LONG-RANGE PLANS EVALUATION

Hillmont

PROPERTY ADDRESS 138 Stancell Drive	APPLICANT McAdams, on behalf of Northwood Ravin	CURRENT ZONING DISTRICT Mixed Use Village (MU-V)
---	---	--

Future Land Use Map (Excerpt)

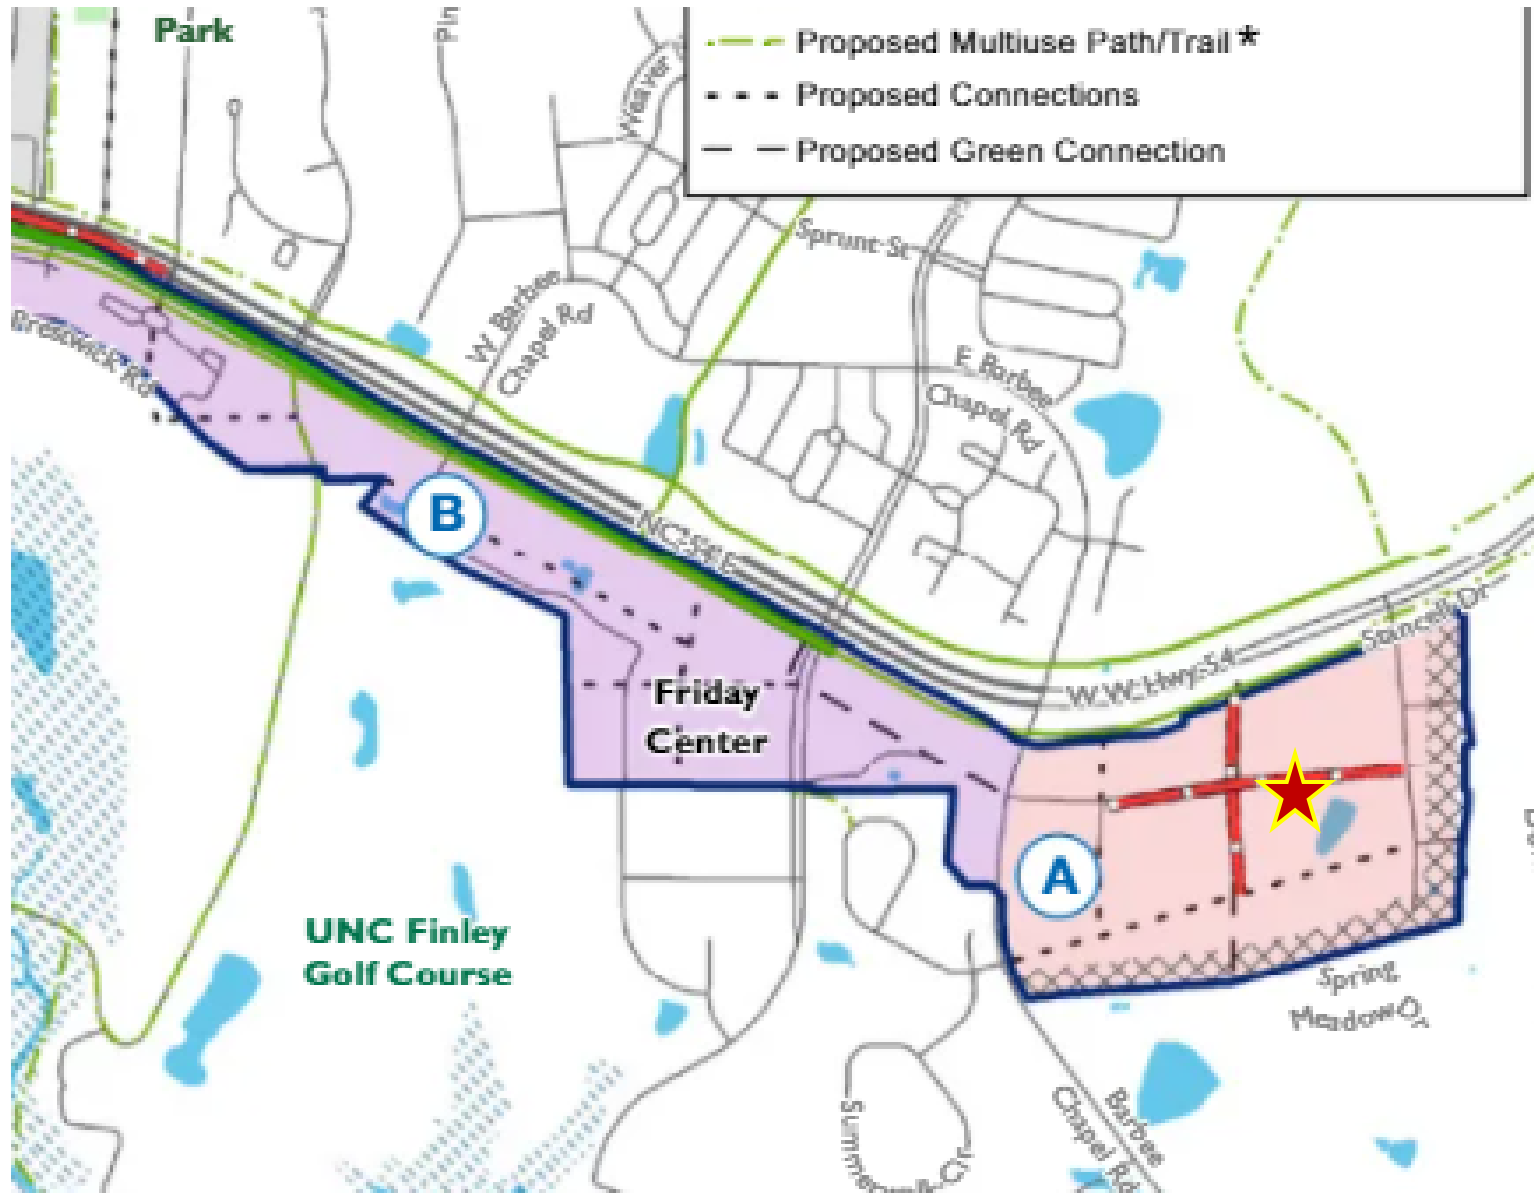
- The project is located in the NC-54 Corridor Future Focus Area, Sub-Area A.
- Multifamily Residential is identified as one of the appropriate Primary land uses.
- Typical Height in the Sub-Area is 4-6 stories.
- No features are shown for Transitional Area, Activated Street Frontages, Proposed Connections, or Future Parks & Open Space impacting the site.

Mobility and Connectivity Plan (Excerpt)

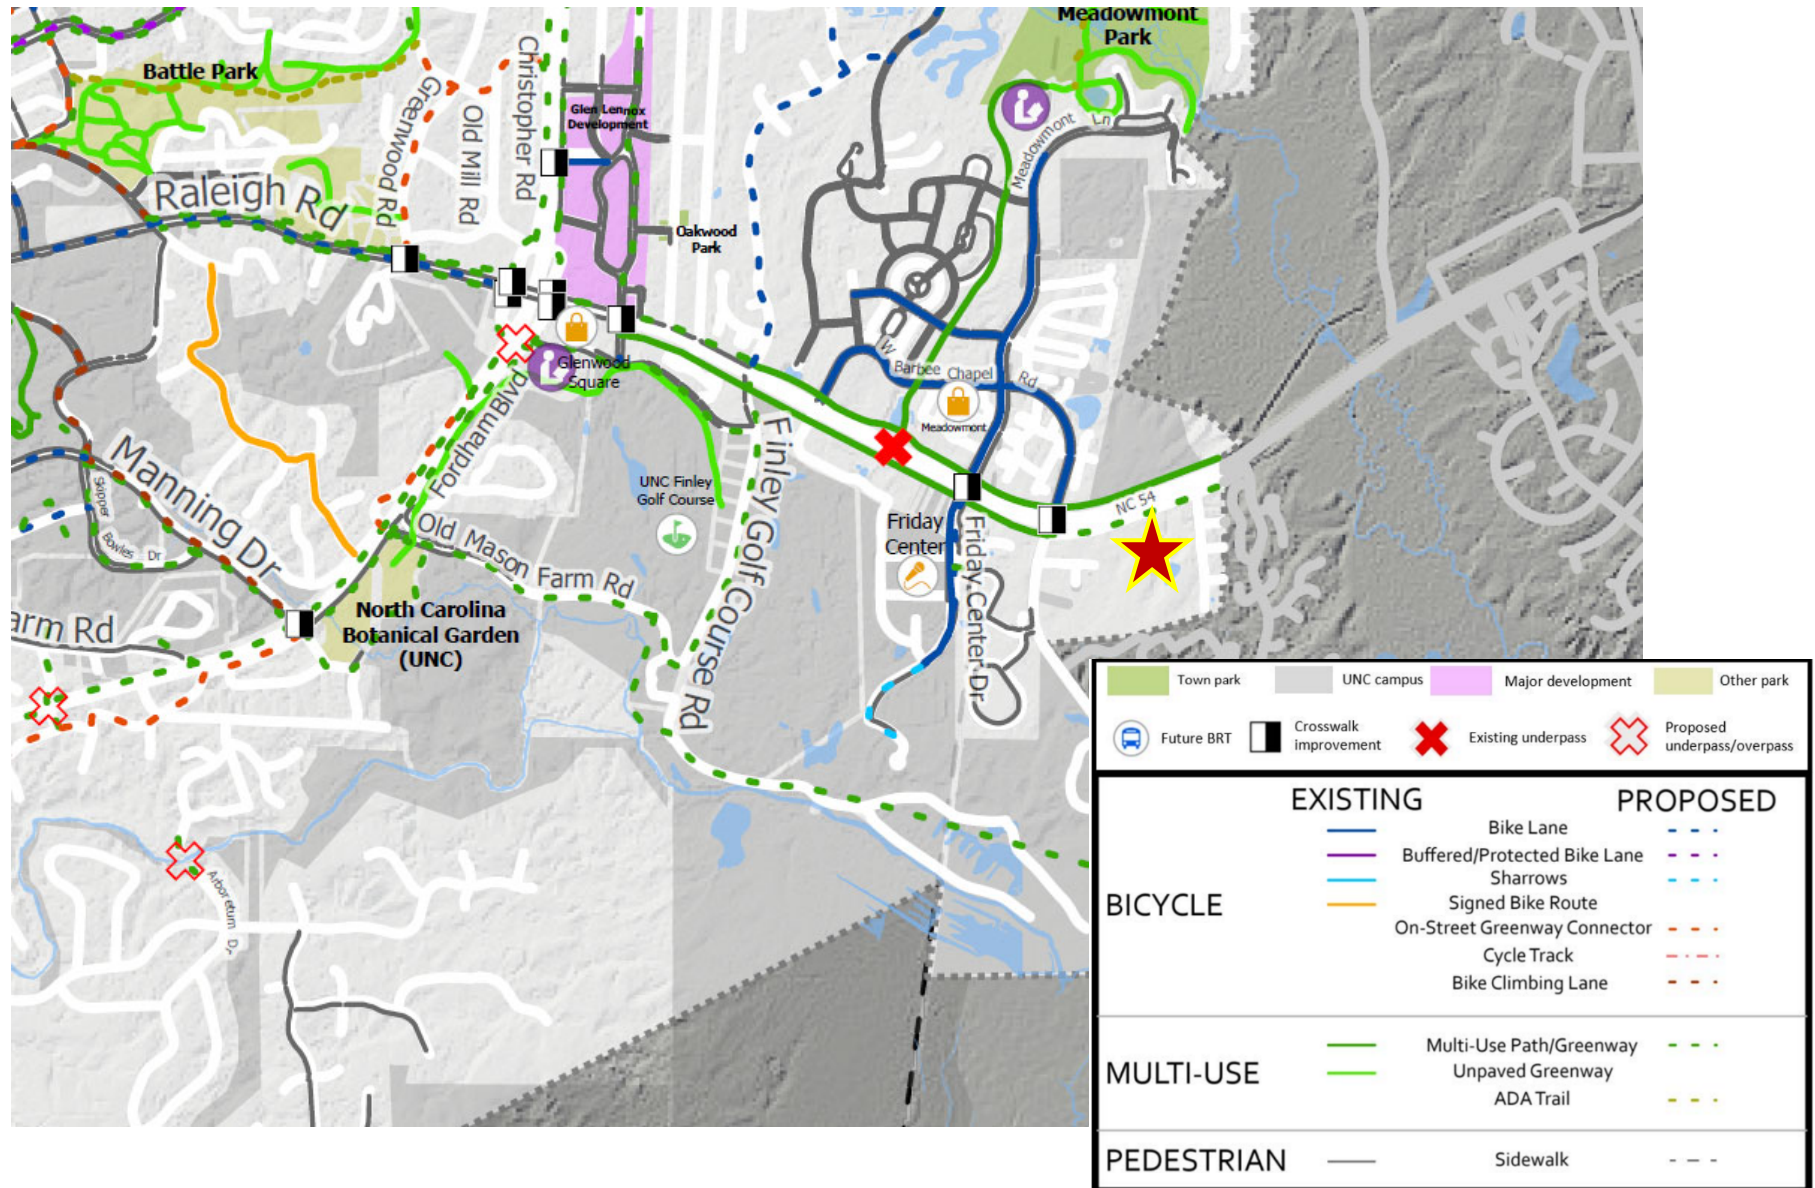
- The site has minimal road frontage.
- Multi-Use Path/Greenway is proposed on the north edge of the site along NC-54.
- A future *Bus Rapid Transit station* is located within ¼ mile of the site. The applicant should **coordinate with Chapel Hill Transit** for the latest information on BRT design, station locations and any potential connections.

Greenways Master Plan (Excerpt)

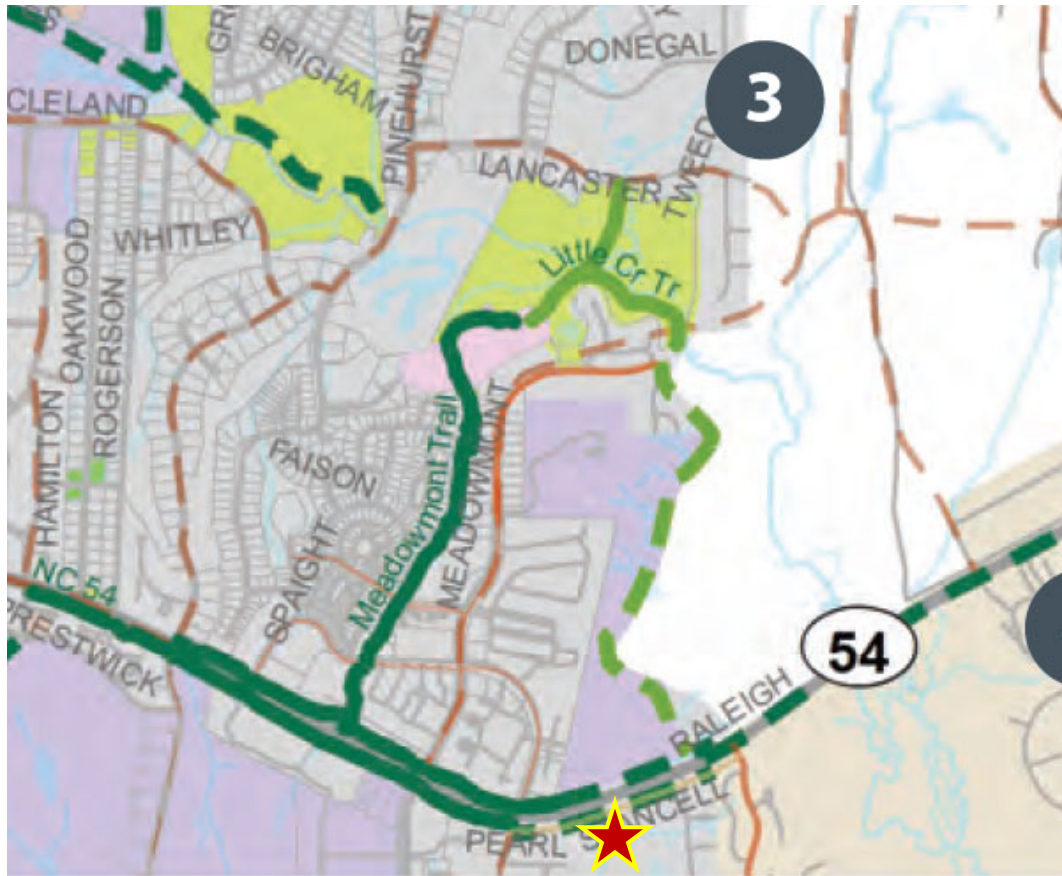
- Proposed paved, north side of site along NC-54.
- The applicant should **coordinate with Chapel Hill Parks & Recreation** for the latest information on trail alignment, design, and construction timing.

Cultural Arts Plan (Excerpt)

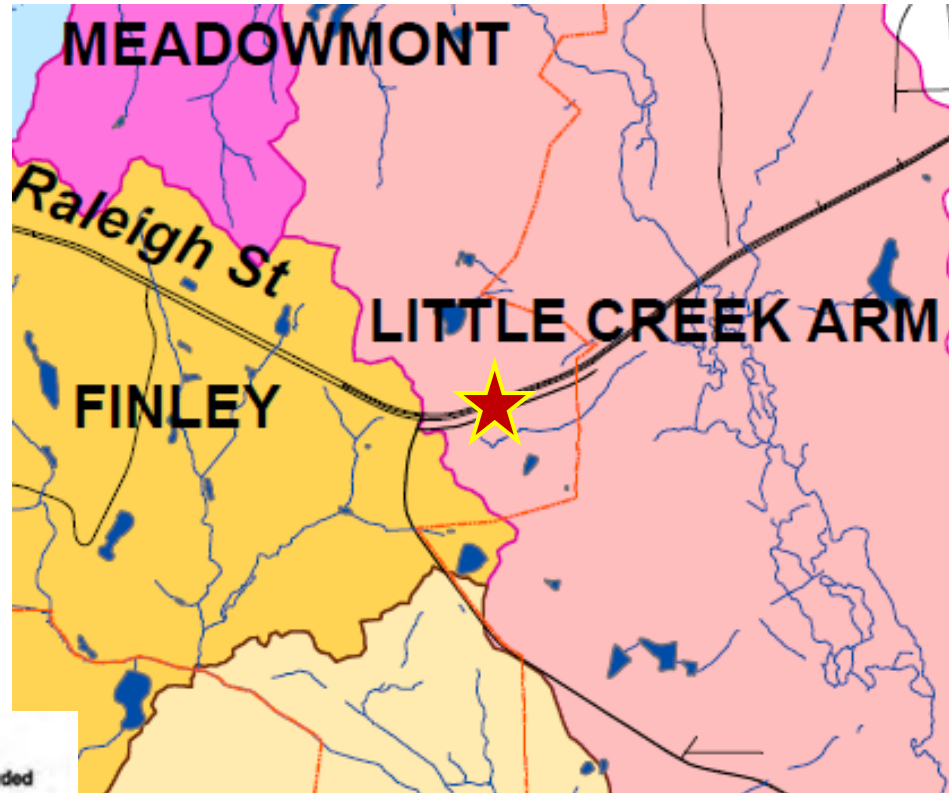
- No opportunities for integrating public art are identified at locations that impact the site. There are adjacent nodes adjacent to the site.
